UNITED STATES PATENT AND TRADEMARK OFFICE

APPLICATION NO.	FILING DATE	FIRST NAMED INVENTOR	ATTORNEY DOCKET NO.	CONFIRMATION NO.
10/028,305	12/28/2001	Gee Sung Chae	2658-0283P	2901

Office Action Summary

DETAILED ACTION

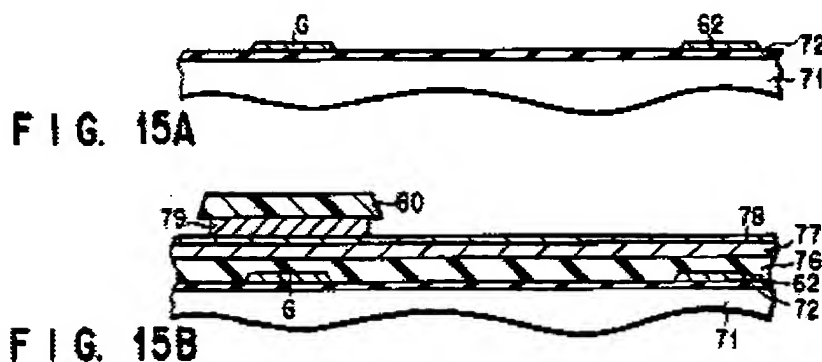
As to claim 1, APA discloses a conventional liquid crystal display device in Figures 1-5 (Specification pages 1-5), comprising: a substrate, 1; a gate electrode, 3, over the substrate; a first semiconductor layer, 15, over the gate electrode; a second

semiconductor layer, 17, over the first semiconductor layer, source, 5, and drain, 7, electrodes (Applicant's first metal layer) on the second semiconductor layer, the first metal layer patterned in a same pattern as the second semiconductor layer such that the first metal layer and second semiconductor layer define the channel, 30 (Applicant's separation region) per Figure 3C (specification page 3, lines 28-31). Please note that this is well known in the art to take only one photolithography pattern (Applicant's patterned in the same pattern).

APA does not explicitly disclose source and drain electrodes over the first metal layer, the source and drain electrodes patterned the same as the first metal layer and the second semiconductor layer define first upper portion of the separation region, and the source and drain electrodes include a second and a third metal layer.

As to claim 2, APA discloses a device, further comprising: an insulating layer in between the gate electrode and the first semiconductor layer; a protective layer, 21, over the source and drain electrodes and defining a second upper portion of the separation region (Figure 3D) and a contact hole, 19b, exposing a portion of the drain electrode; and a pixel electrode, 23, in the contact hole (Figure 3E).

(1) APA discloses in the specification, page 1, line 15, through page 5, line 24, (Figures 1-5) the method of manufacturing a liquid crystal display device comprising a first metal layer on the second semiconductor layer, the first metal layer patterned in the same pattern as the second semiconductor layer such that the first metal layer and second semiconductor layer define the channel, 30 (Applicant's separation region) per Figure 3C (specification page 3, lines 28-31). Please note that this is well known in the art to take only one photolithography pattern (Applicant's patterned in the same pattern).

(2) APA discloses in the specification, page 1, line 15, through page 5, line 24, (Figures 1-5) the method of manufacturing a liquid crystal display device comprising patterning the first metal layer and the second semiconductor layer in a same pattern per Figure 3C (specification page 3, lines 28-31). Please note that this is well known in the art to take only one photolithography pattern (Applicant's patterned in the same pattern).

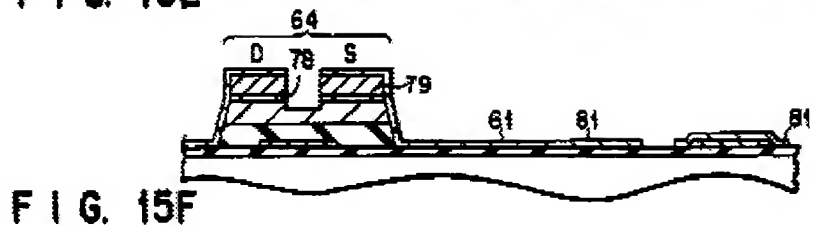
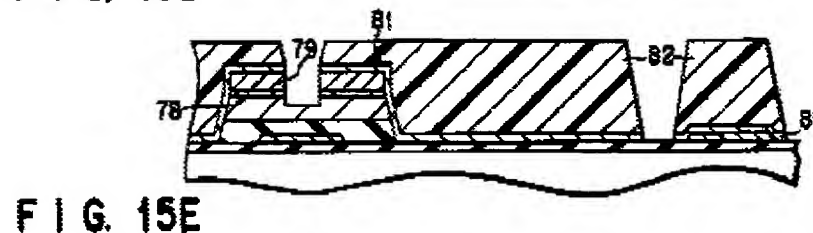
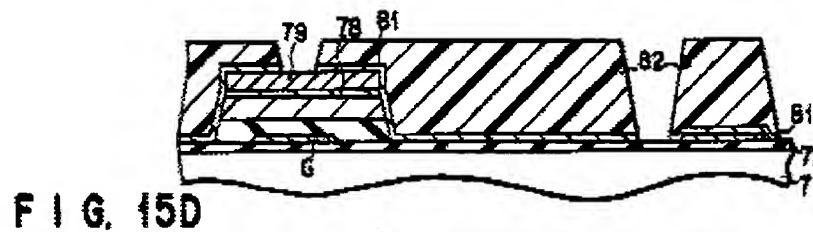
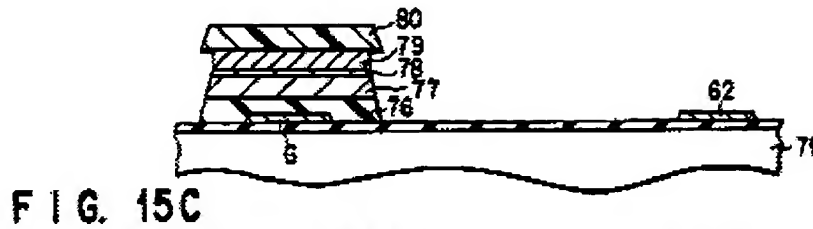
Ueda teaches and embodiment in Figures 15A-15F (col. 12, line 58, through col. 18, line 33, especially col. 16, line 64, through col. 18, line 33) the use of source, S, and drain, D, comprised of Aluminum and Molybdenum disposed on Molybdenum (Mo/Al/Mo) (comprises Applicant's electrodes over the first metal layer), the source and drain electrodes patterned the same as the first metal layer and the second semiconductor layer (col. 17, lines 22-42) define first upper portion of the separation region, and the source and drain electrodes include a second (Al) and a third (Mo) metal layer, in order to use a low resistance metal such as Aluminum for improved conductivity of the circuit components (col. 17, line 55, through col. 18, line 5).

Ueda is evidence that ordinary workers in the art of liquid crystals would find the reason, suggestion, or motivation to add source and drain electrodes over the first metal

As to claim 15, APA in view of Ueda discloses the method of claim 8 above, wherein the patterning of the first metal layer and second semiconductor layer define channel region includes removing a portion of the first metal layer and second metal layer corresponding to the gate electrode and exposing the first semiconductor layer (Figure 15F, and col. 17, lines 14-67).
